**Subject: Notice of Draft Supplemental Environmental Assessment (SEA) for the Bay Point Key/Saddlebunch Key Wastewater System, Monroe County, Florida.**

Re: Federal Emergency Management Agency, Hazard Mitigation Assistance, Draft Supplemental Environmental Assessment (DSEA) for the Bay Point Key and Saddlebunch Key Wastewater System, Monroe County, Florida

**PROJECT:** Federal Emergency Management Agency, Hazard Mitigation Assistance,  
Draft Supplemental Environmental Assessment (SEA) for the Bay Point Key  
and Saddlebunch key Wastewater System, Monroe County, Florida

**Subject: Bay Point Key/Saddlebunch Key Wastewater System, Monroe County Supplemental Environmental Assessment [SAI#: FL200305122041C]**

**Figure 4. Proposed Bay Point and Saddlebunch Keys  
WWTP Preliminary Drawings (FKAA, 2002)**

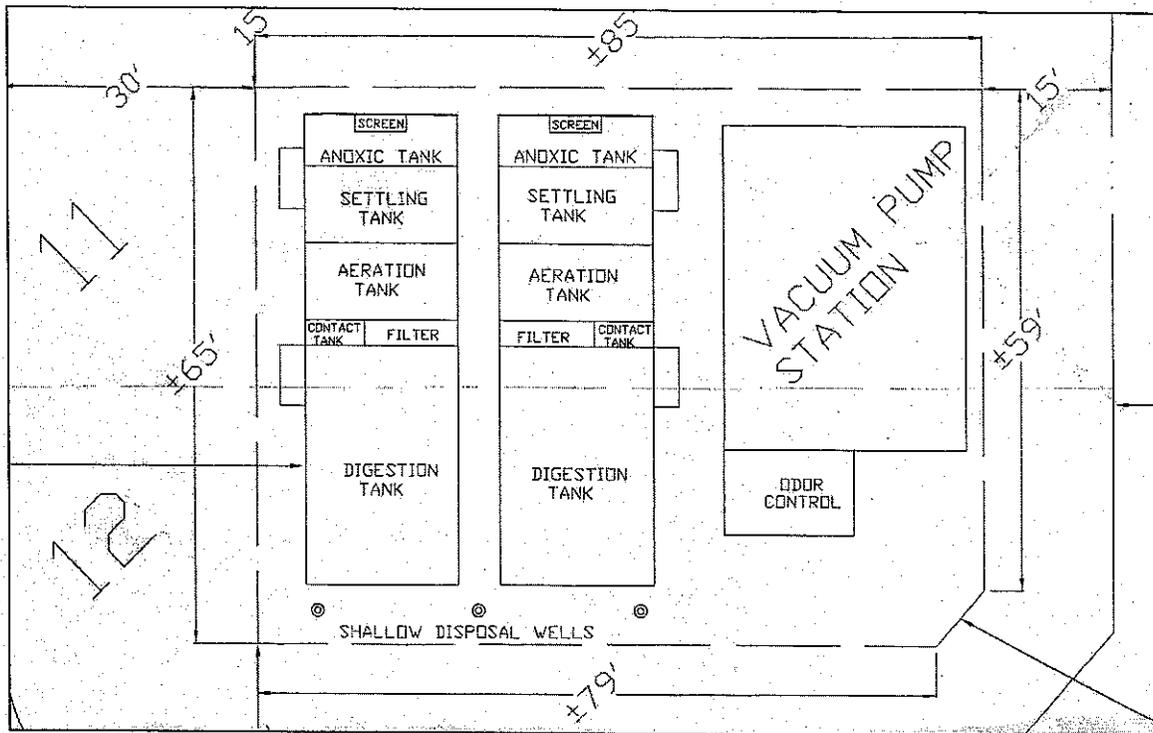
- (10) The treatment plant drawing (Figure 4) is out of scale. The digestion tank appears to be larger than the biological process.
- (11) For a lifespan of 30 to 50 years, the treatment plant should be made of concrete.
